Subject: [EXT] North Drainage Ditch Response to Approval

RE: Response to Approval with Modifications

Revised Investigation Work Plan North Drainage Ditch Area Marathon Petroleum Company LP, Gallup Refinery (dba Western Refining Southwest LLC) EPA ID# NMD000333211 HWB-WRG-19-009

March 4, 2021 Approval with Modifications – Revised Investigation Work Plan North Drainage Ditch Area (September 2019)

Figure 2 in the Work Plan has been revised to include the location of the historic borings. Attached to this correspondence is a copy of Figure 2.

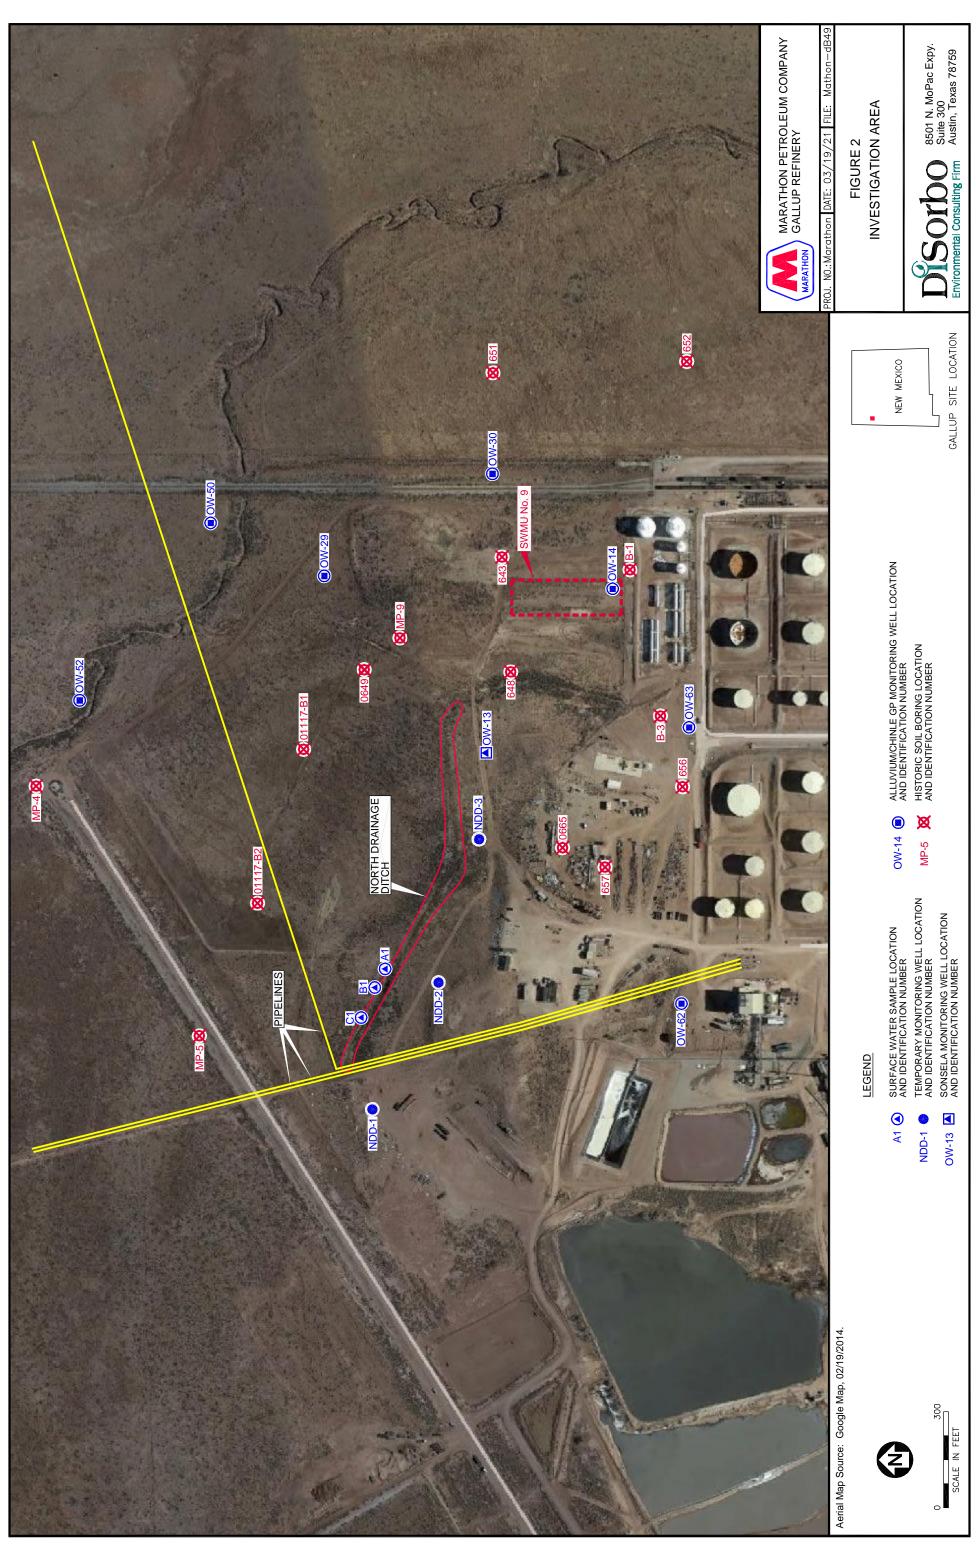
The response to NMED's Disapproval Comment 2 states, "[t]he missing historic borings [01117-B1, 0117-B2, 648, 643, 649, 651, 652, 665, 656, 657, MP-4, MP-5, MP-9, B-1, and B-3] are included in Appendix B..." The boring logs are appropriately included in Appendix B; however, the Work Plan does not include a figure that identifies the location of the borings. Provide a figure that identifies the location of the historic borings.
